**SANTEE COMMUNITY CENTER
CIP 2018-31**

ADDENDUM NO. 5

This Addendum No. 5 (32 pages in total) forms an essential part of the contract documents by revising the following:

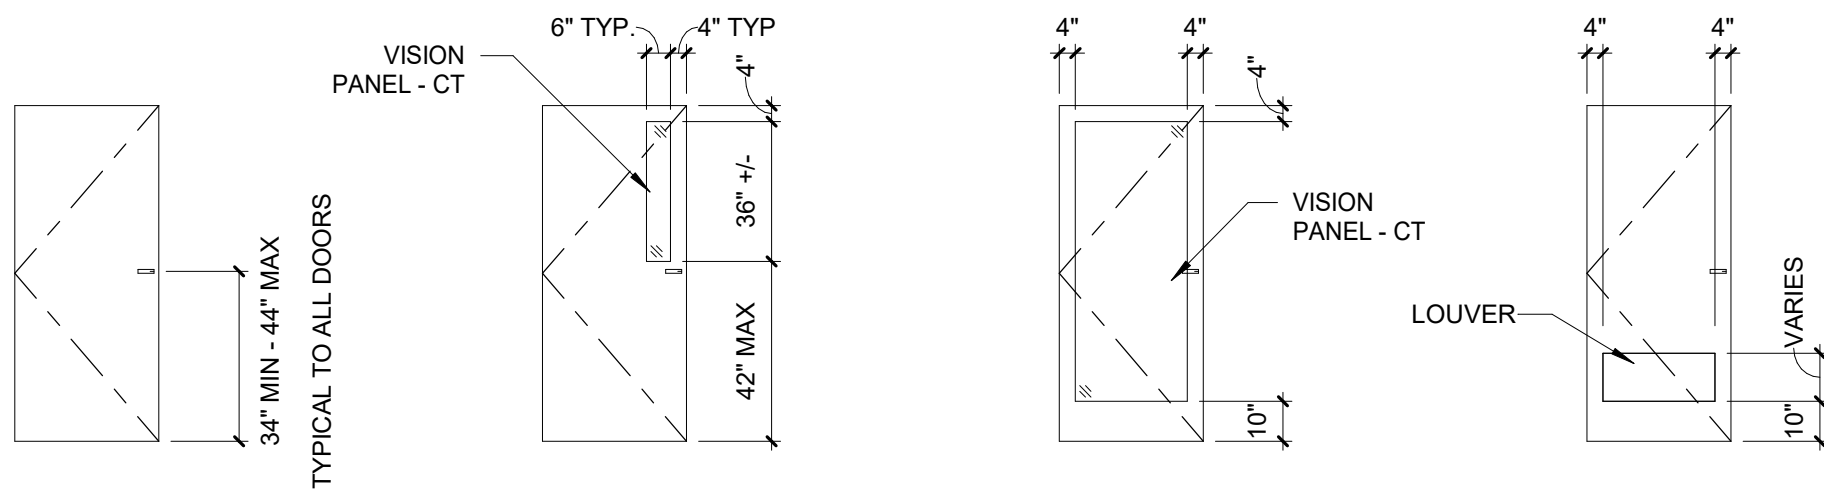
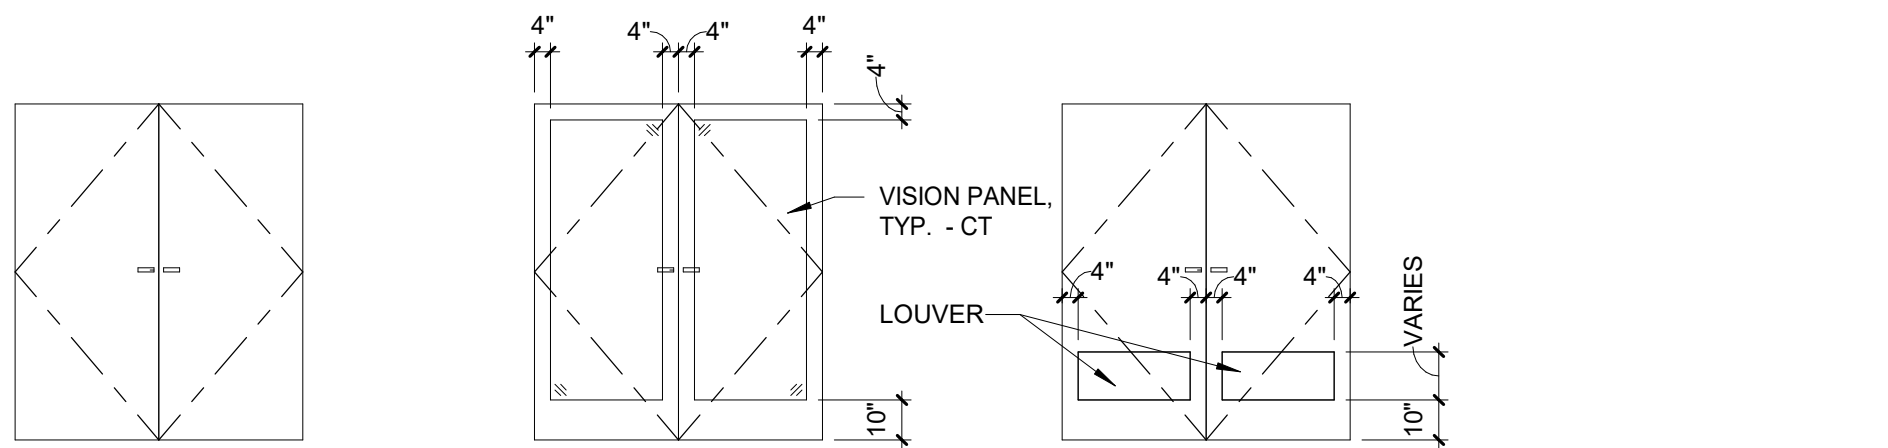
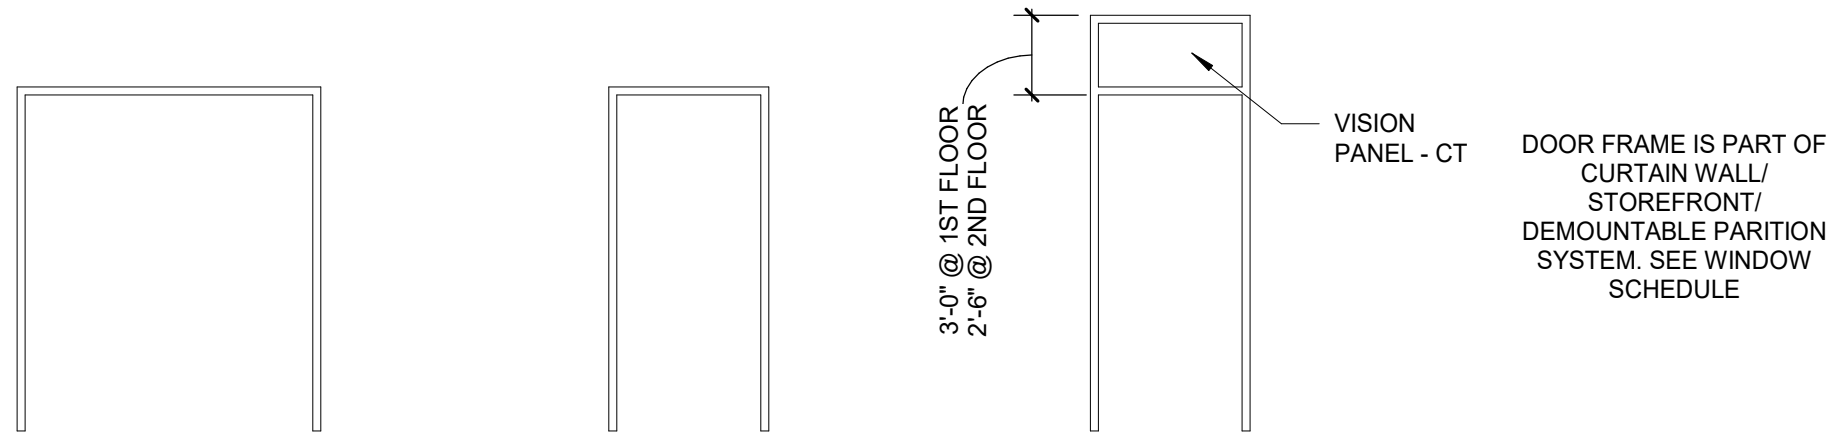
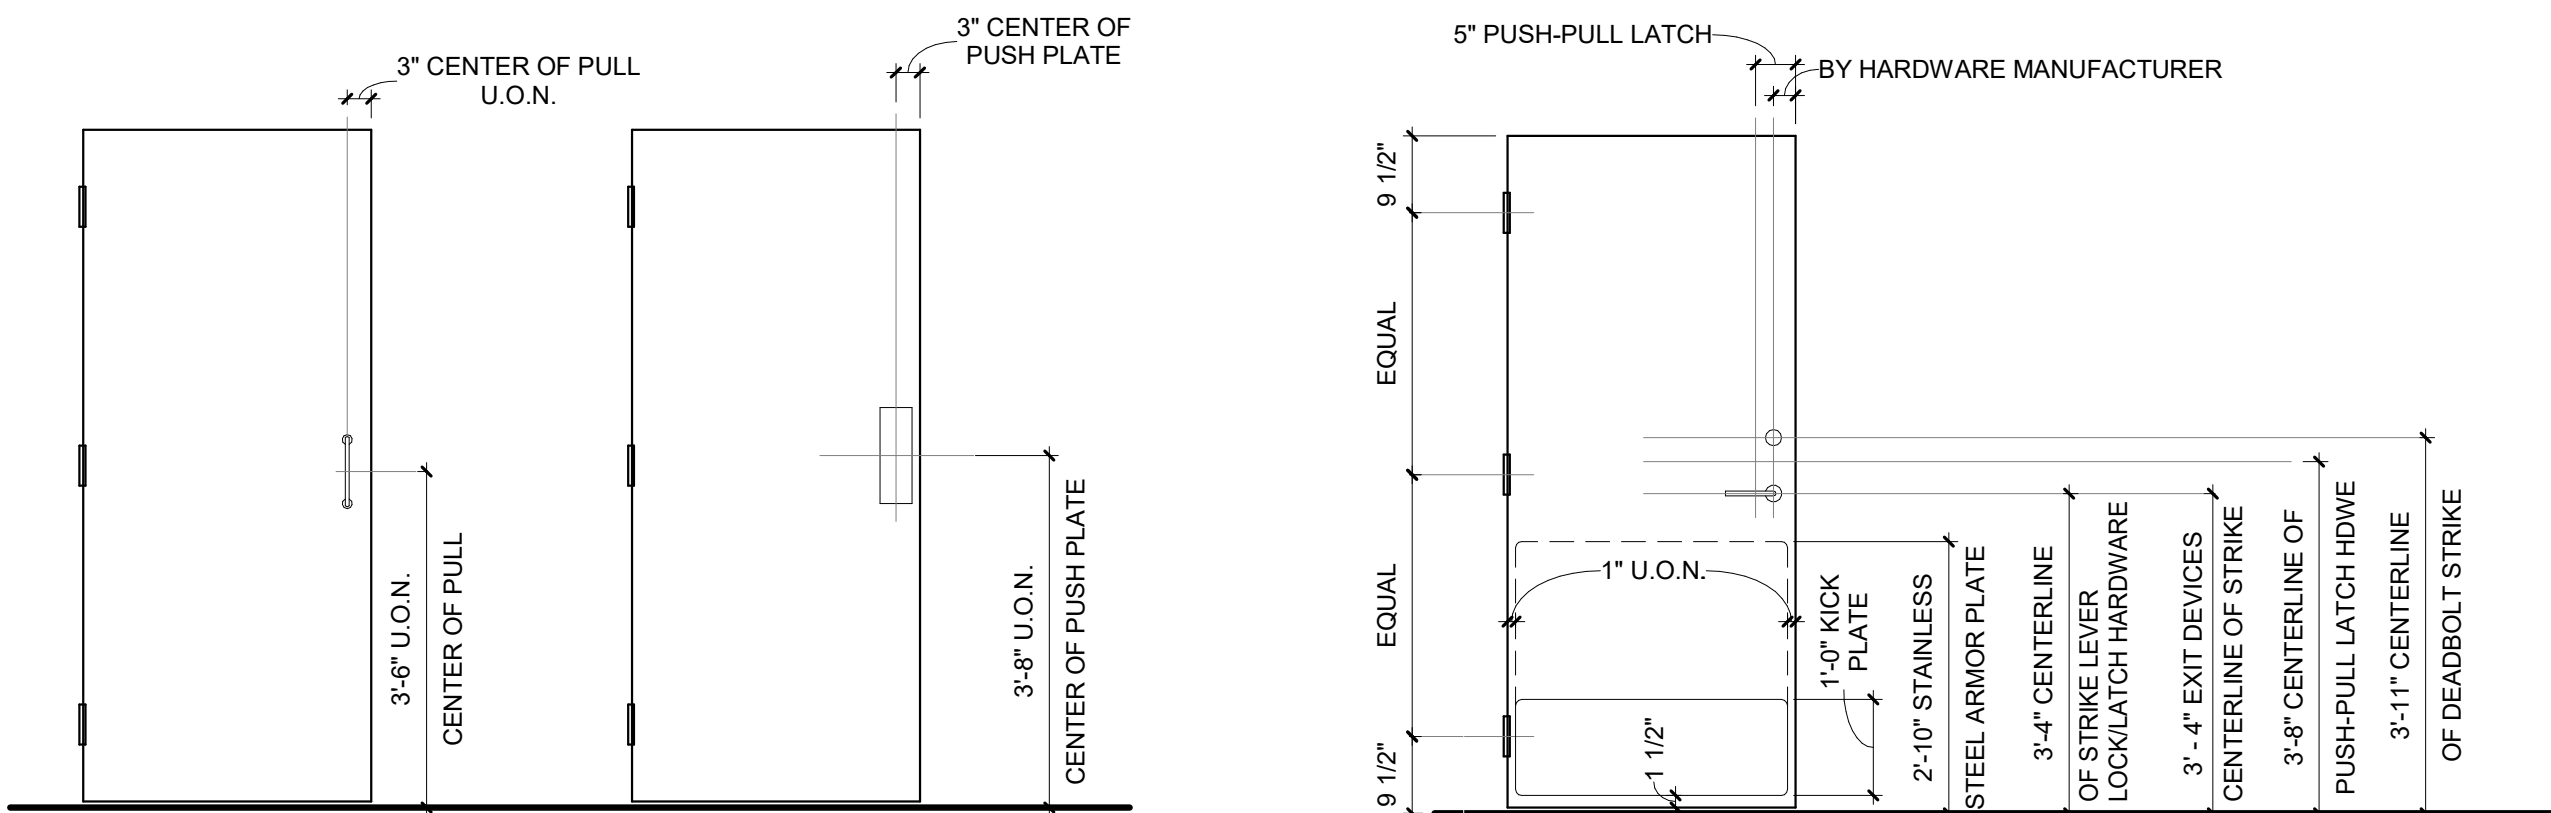
- For clarity, added dimensions to openings 101A & 101B in elevation 3/A8.13.
- 5C-7 Drawing Sheet **A9.11 – DOOR SCHEDULE**
- Revised door hardware set callouts.

- Removed 45 minute rating from 101A, 101B, and 200B.
 - Removed 45 minute rating from doors 100A, 100B, 100C, & 100D
- 5C-8 Drawing Sheet **A9.21 – WINDOW CONFIGURATIONS**
